Ann Arbor VA
Parking Deck Expansion

Proposed handrail at
stone cap

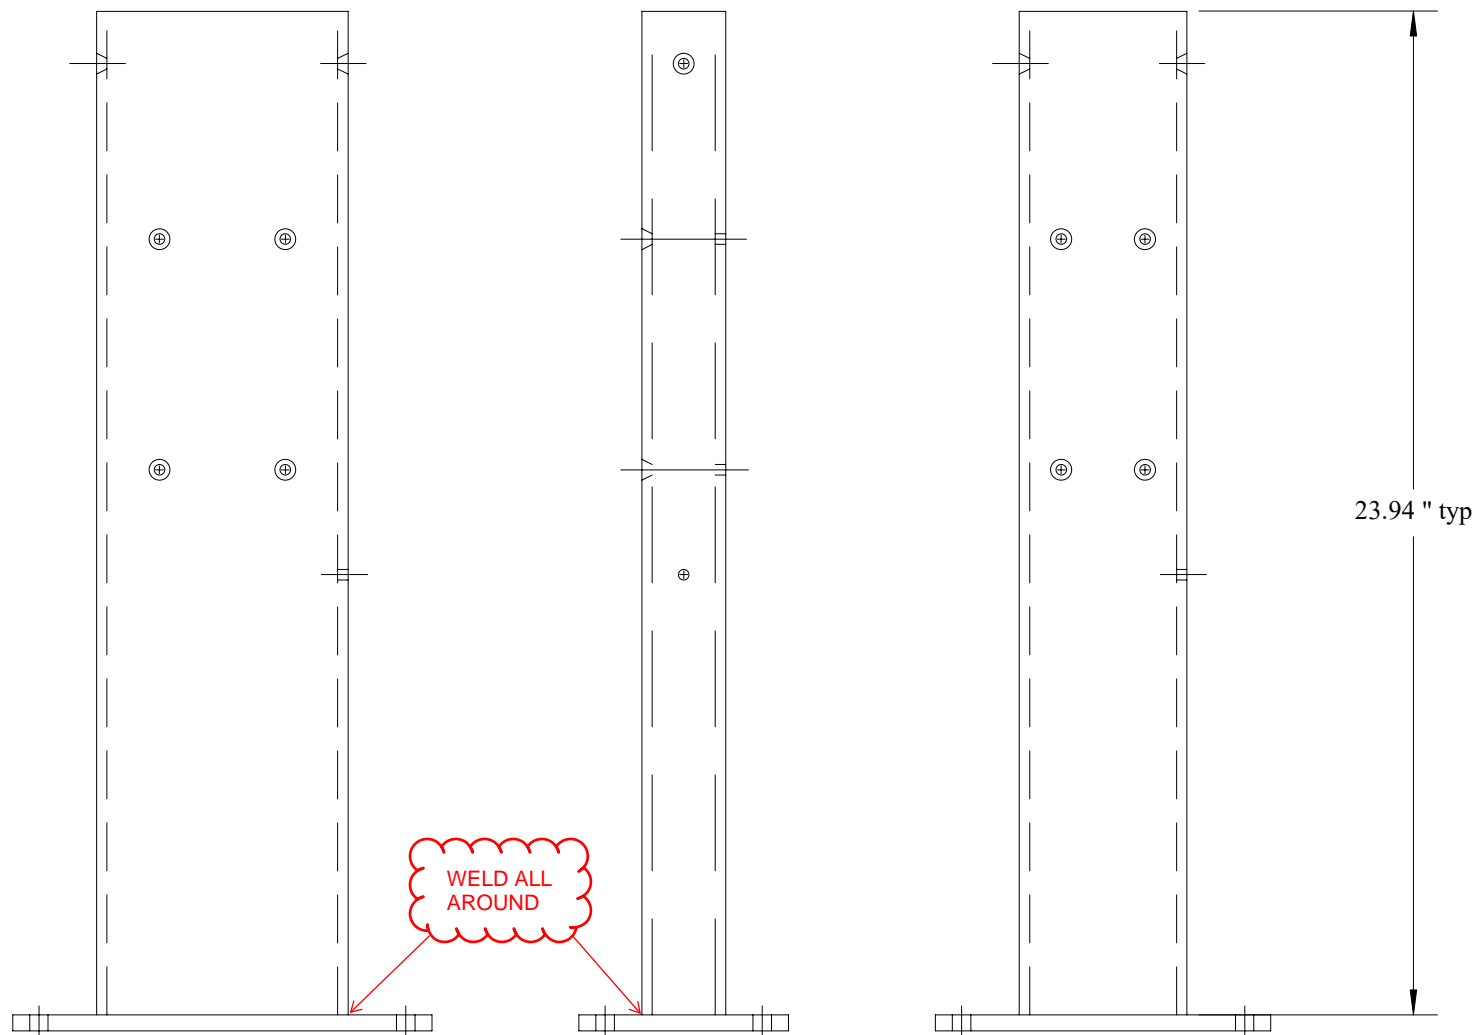
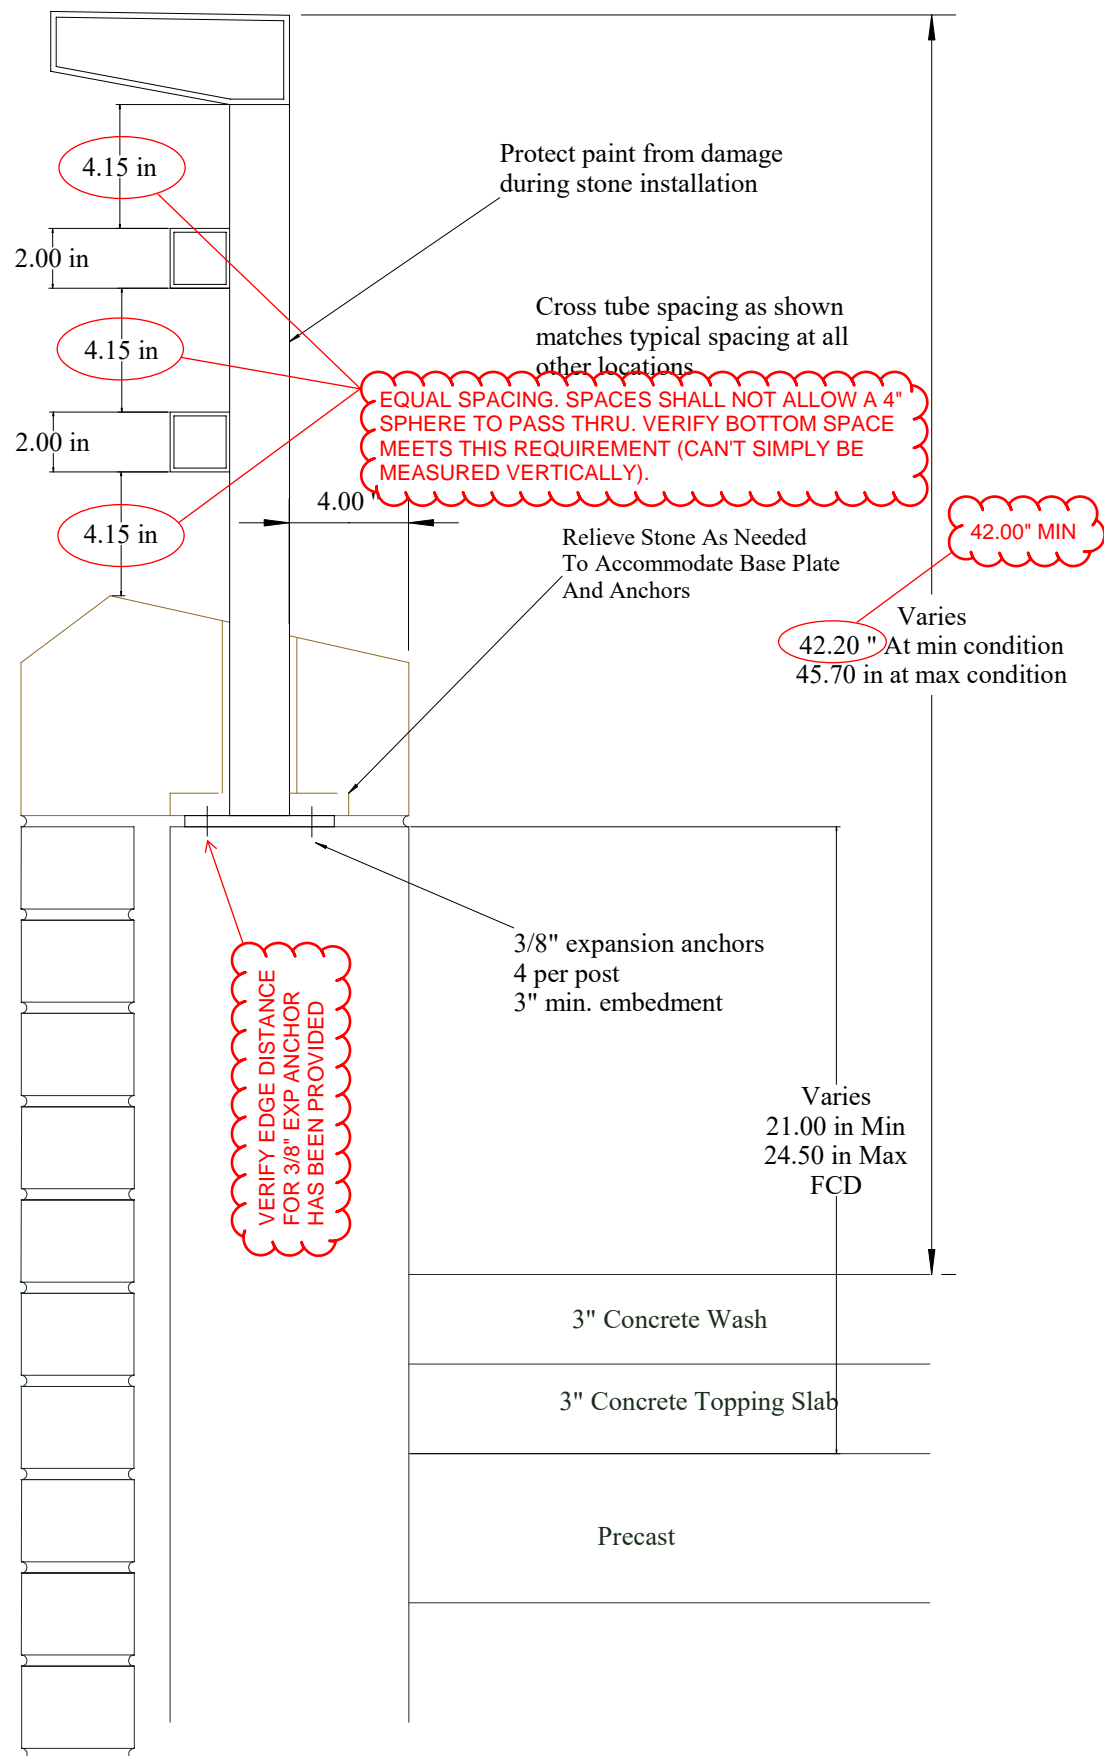
POST SPACING TO MATCH
LEVELS ABOVE

DESIGN TO MEET LOADING
REQUIREMENTS - SEE SPECS
